Procurement Department
IFB: Restoration of Four (4) Stairs at Performing Arts Center
Project SU-111919
Addendum #1 * March 20, 2020

Responses for Request For Information #1

Project Name: Restoration of Four (4) Stairs at
Performing Arts Center

DRAWING NUMBER:
E1 of 1

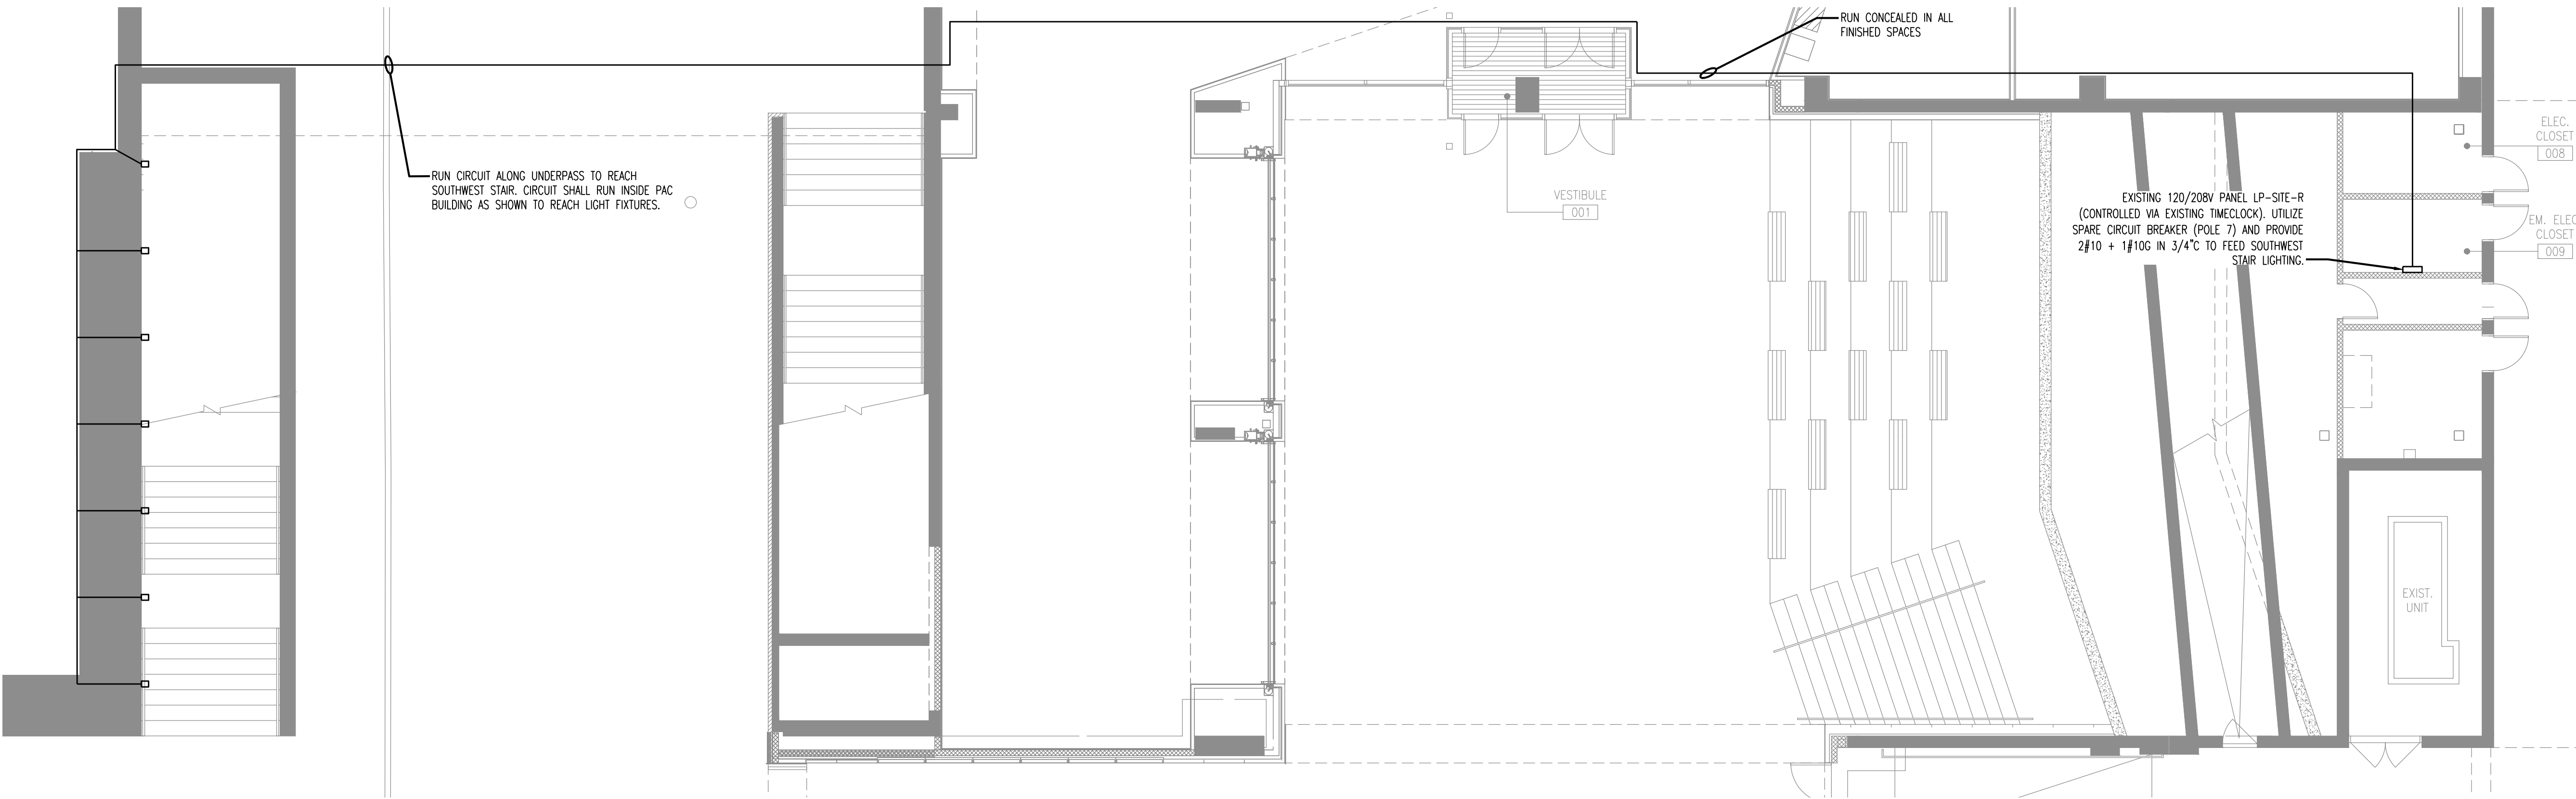
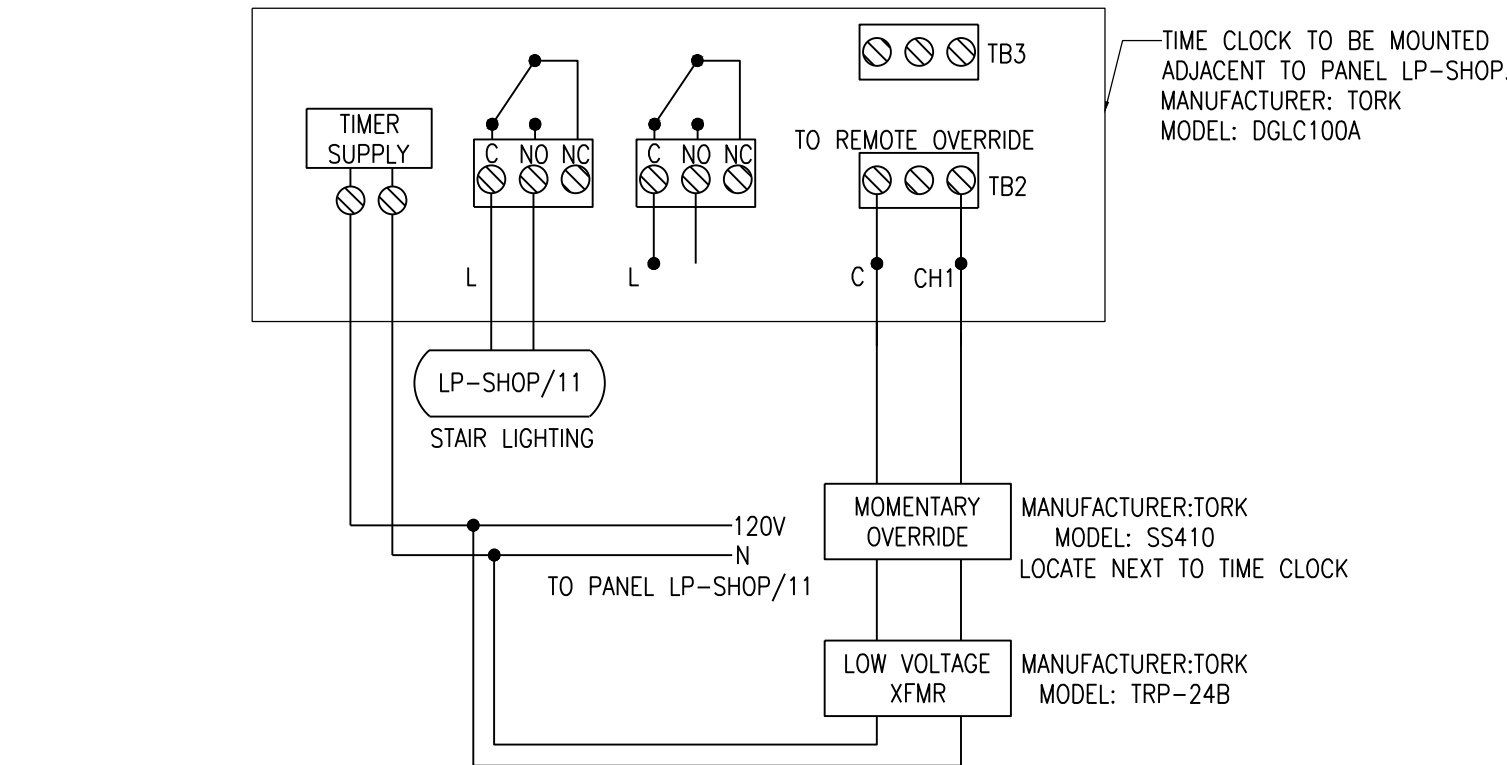
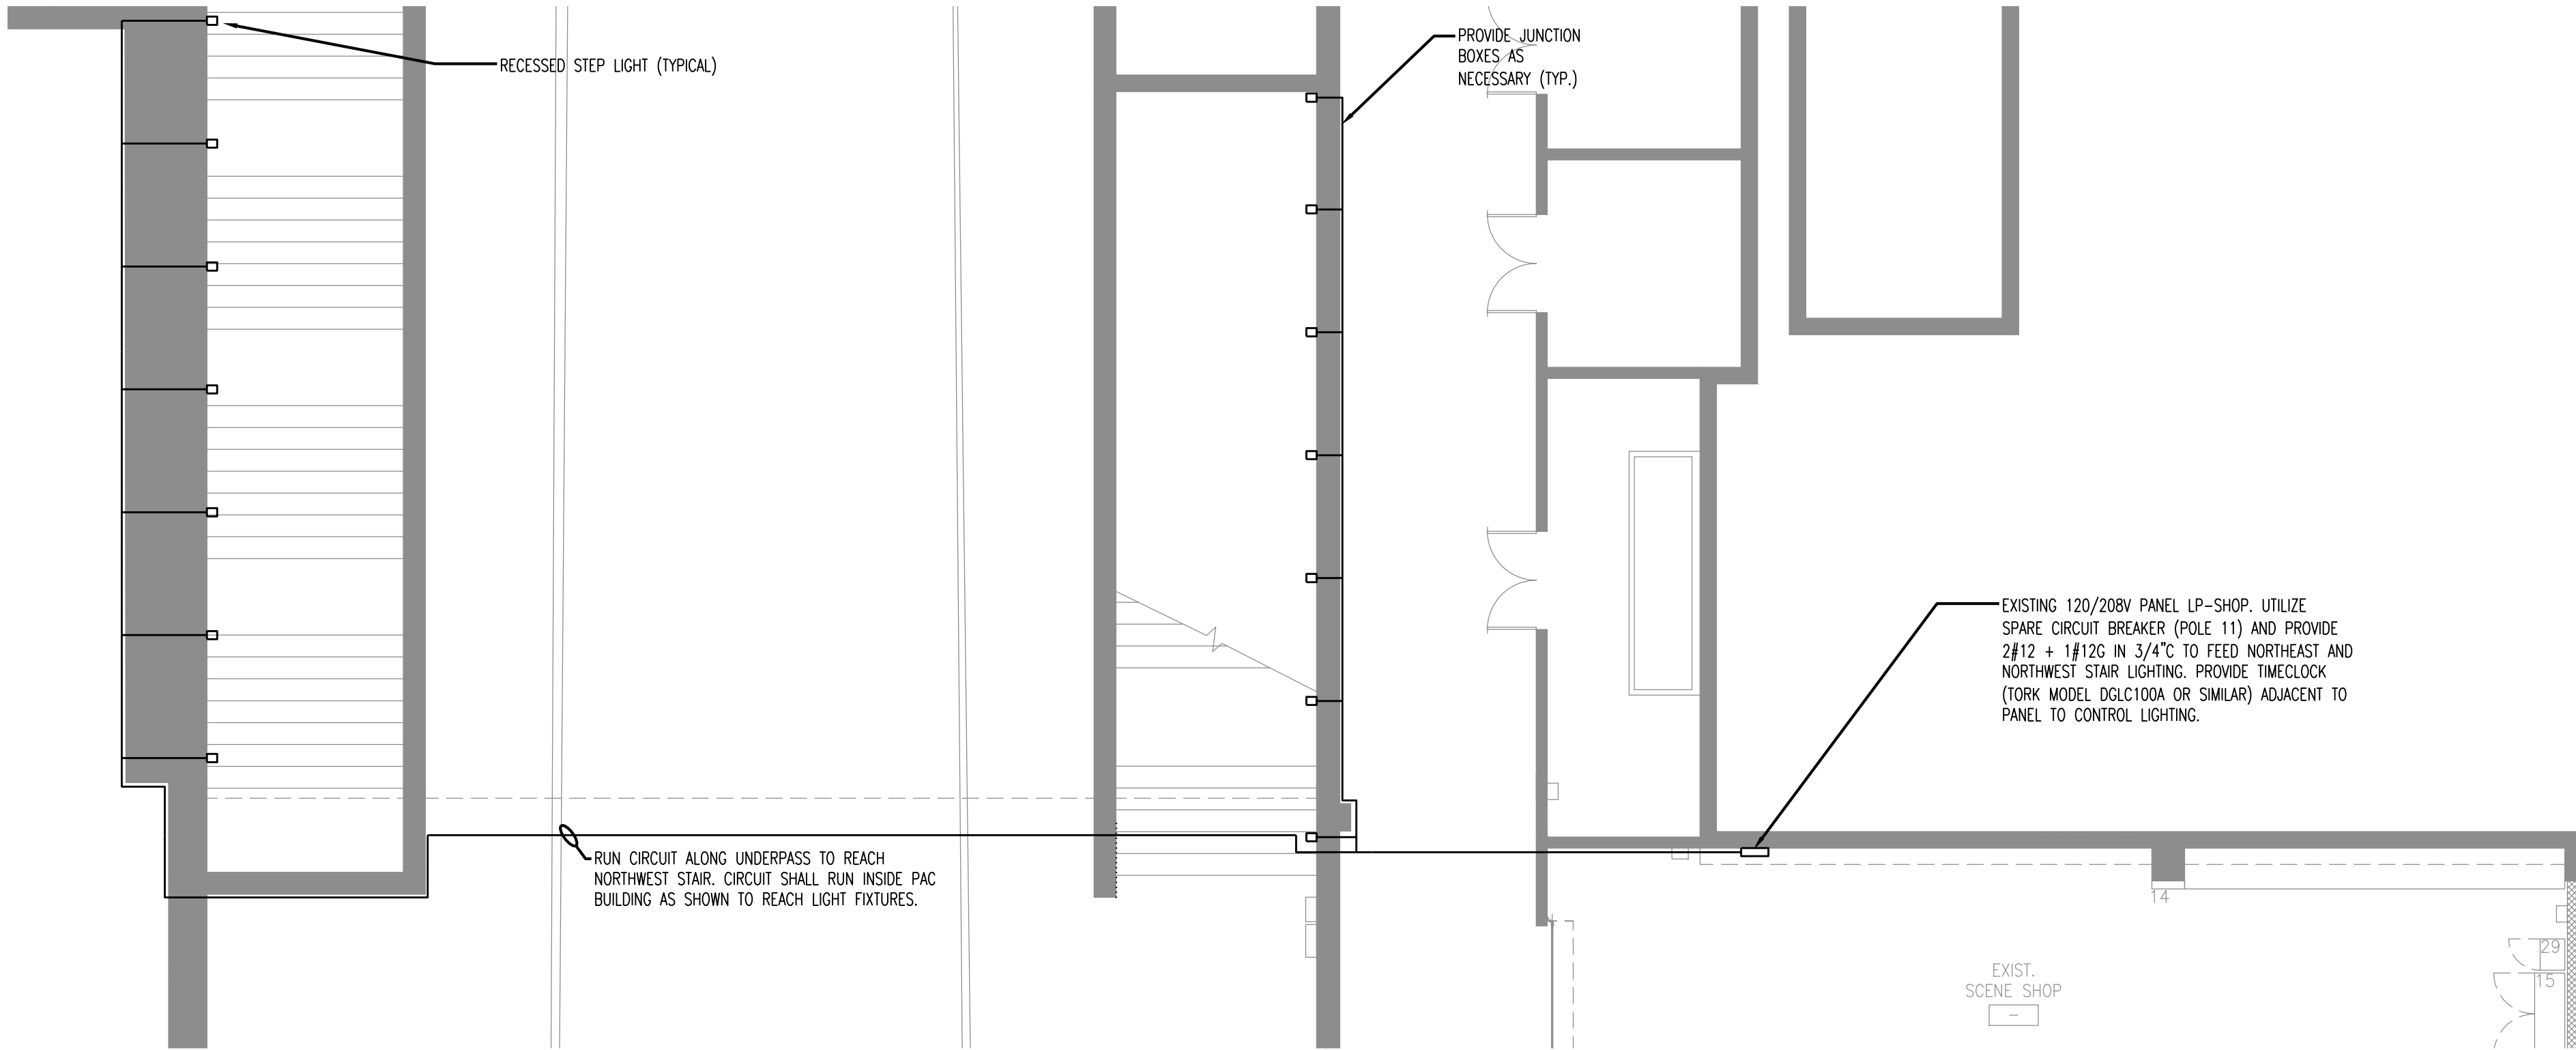
1. As per Specification sections, 260519, 260533.13, 260533.16, it mentions about Cables, Conduits and boxes. But there is no drawing showing it. Do we have to install new conduits and cables and connect them to the existing panels or install new panels. Please provide the quantity and locations for it. Please provide detailed drawings showing from where to where panel locations and also details of Conduits and wires. Please advise.
2. The drawing E1 is not very clear it has some overlapping portions. Please provide a clear drawing.

1. Alternate 3 is referenced on Electrical drawing E1, but contractor can find no other reference to alternate 3 in the specifications or bid form. Additionally, if there is an Alternate 3 is there an Alternate 2 anywhere? Please advise.

1. Drawing E-1 indicates all circuits and conduit routing. Drawing E-1 clearly indicates the contractor to utilize spare circuit breakers in existing panels LP-SHOP (located in scene shop) for north stairs and panel LP-SITE-R (located in electrical closet) for south stairs. The entire project requires (2) circuits to be run from existing panels, wire sizes are indicated on plans. Junction boxes shall be provided by contractor as necessary. All locations (panels, circuit routing, stair lights) are indicated on drawing E-1.
2. There are no overlapping items - however see attached E-1 drawing which has been revised to be more clear.

1. There is no Alternate #2 or Alternate #3 shown on Drawing E1.
